## **Downstream Analysis**

# Proposed Gooding Avenue Hotel Downstream Analysis Coincident Peaks

## Two Downstream Combining Hydrographs

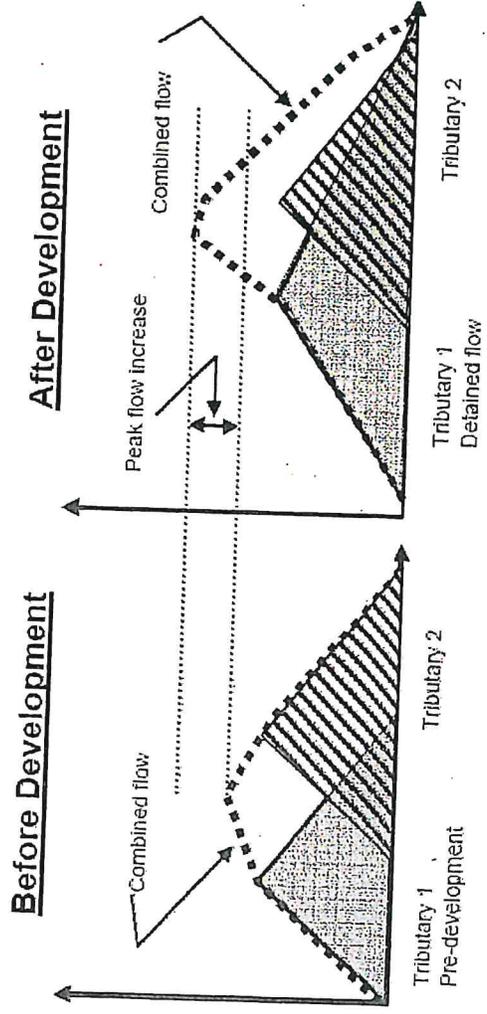
The figure above shows a case resulting from delaying the recession and extending the recession limb of the hydrograph; the peak flow rate in the main channel increases.

The Applicant has contended during the RIDEM wetland review process that a Downstream Analysis was not required since they reduced the peak runoff rate. I have attached the pertinent sections of the RI Stormwater Design and Installation Standards Manual, which specifically explains and uses a graph to illustrate why a downstream analysis is required, even though there is a reduction in the pre and post runoff rates.

The Applicant attempted to satisfy the Downstream Analysis by modeling the section of Silver Creek as a 'Reach' using *HydroCAD* Stormwater modeling software. **This assessment is categorically wrong.**

Figure 3-1 Graphical Representation of Coincident Peaks (Ogden, 2000)

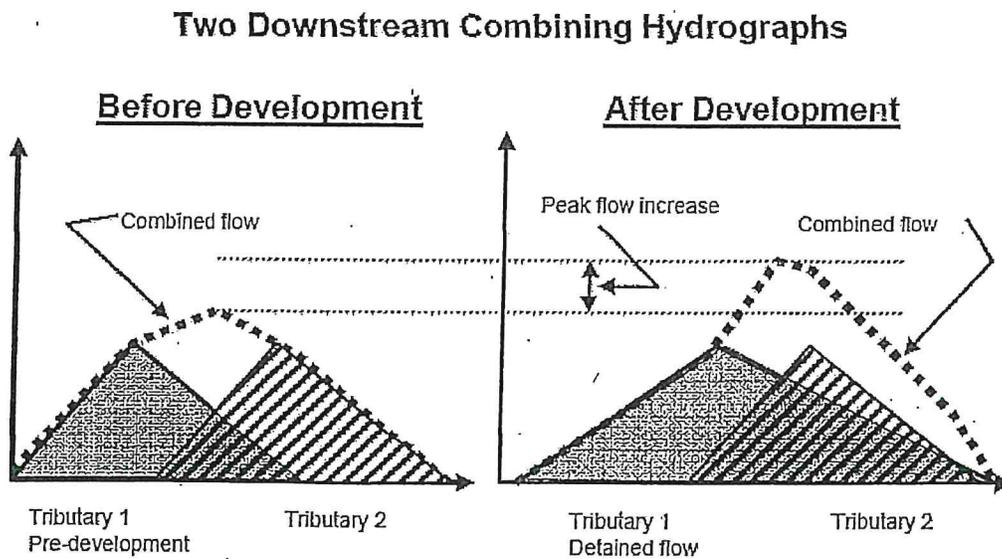
A number of hydrologists have noted that overbank and extreme flood control approaches do not always provide full downstream control from the out-of-bank events, due to differences in timing of individual peak discharges in the downstream portion of the watershed. Depending on the shape and land use of a watershed, it is possible that upstream peak discharge may arrive at the same time a downstream structure is releasing its peak discharge, thus increasing the total discharge (see Figure 3-1). As a result of this "coincident peaks" problem, it is often necessary to evaluate conditions downstream from a site to ensure that effective out-of-bank control is being provided.
